HISTORIC AND DESIGN REVIEW COMMISSION

HDRC CASE NO: 2015-299

ADDRESS: 320 E LOCUST

TYPE OF WORK: New Carport, Deck and Fencing at Rear of Property

SITE PLAN
SCALE: 1" = 20'-0"

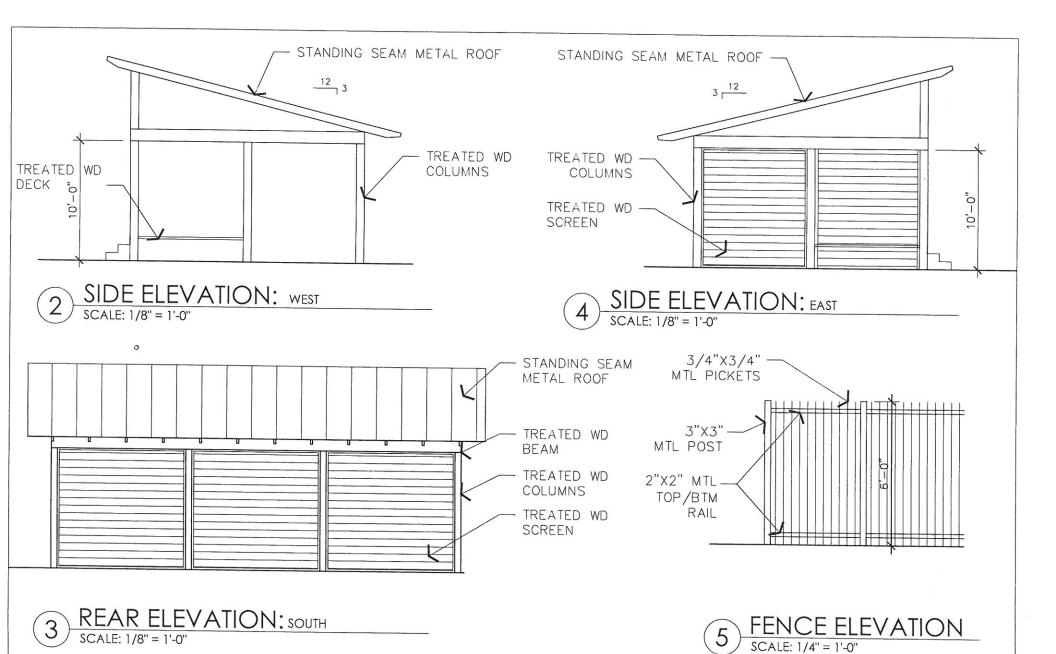
- e. According to the Guidelines for New Construction on Orientation, 4.B.i., the garage orientation should match the predominant orientation found along the block. The carport will be situated in the rear yard. The applicant has noted the proposed carport to be located at the southeast, rear corner of the lot with a 10' rear setback and a 5 foot side setback. This is consistent with the Guidelines. This orientation is consistent with the Guidelines.

- f. According to the Guidelines for New Construction 4.B.ii., setbacks should follow historic patterns of similar structures along the streetscape or district for new garages and outbuildings. The applicant has noted the proposed carport to be located at the southeast, rear corner of the lot with a 10' rear setback and a 5 foot side setback. This is consistent with the Guidelines.
